**HumeLink**  
**Material Change in Circumstance Assessment**  
**and**  
**Contingent Project Application Stage 2 (Delivery)**

Submission by Ted Woodley 3 April 2024

**Figure 2 – History of HumeLink cost and benefits estimates (2020 – 24)**

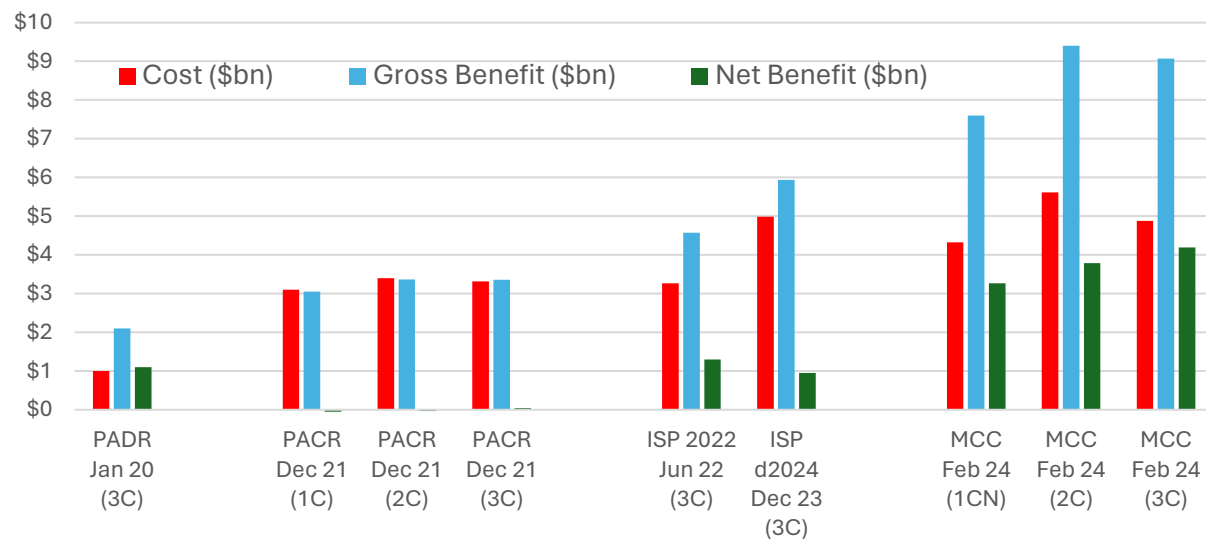
It is noted that:

- the estimated cost (red bars) of the preferred option (3C) has blown out from \$1 billion (PADR) to \$3.3 billion (PACR) to \$4.9 billion (MCCA) – a five-fold increase (not accounting for real figures) in just four years

- the estimated net benefit (green bars) has oscillated from \$1.1 billion (PADR) to near zero or negative (PACR) to \$4.2 billion (MCCA)
- the MCCA estimated gross benefit (blue bars) of \$9 billion is over four times that in the PADR and triple that in the PACR

- the capacity of HumeLink has decreased from 2570 MW in the PACR to 2200 MW now, effectively imposing a 14% cost increase in transmission capacity per megawatt

Figure 2.1: Revised MCC HumeLink capital expenditure cost estimates compared to PACR Addendum capital expenditure cost estimates (\$, real 2023 dollars)

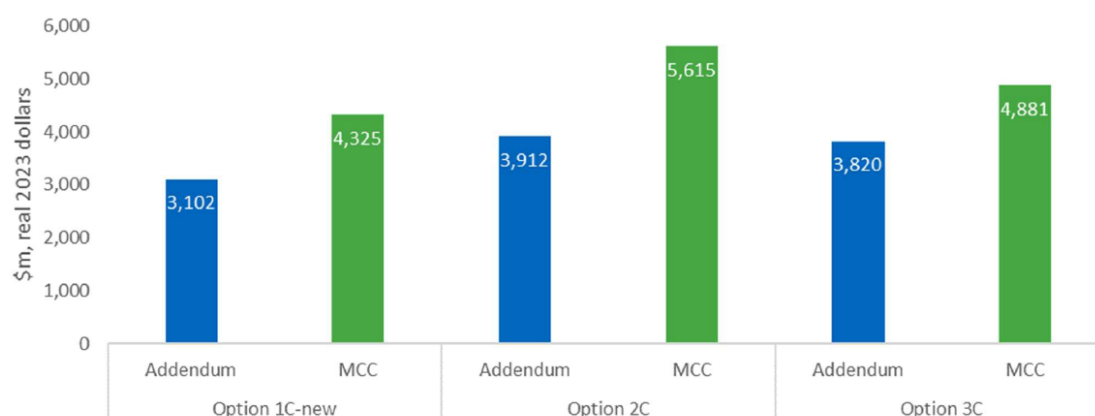
- 17) How is it that the costs for Option 1C-new and Option 2C have increased since the PACR Addendum by a similar amount – i.e. 39% (\$1,223 million) and 38% (\$1,503 million), respectively - yet the cost for Option 3C has only increased by 28% (\$1,061 million)?
- 18) How could the increased cost for 3C be \$162 million less than the increased cost for 1C-new, as Option 3C incorporates all of Option 1C-new plus the leg from Wondalga to Wagga Wagga?
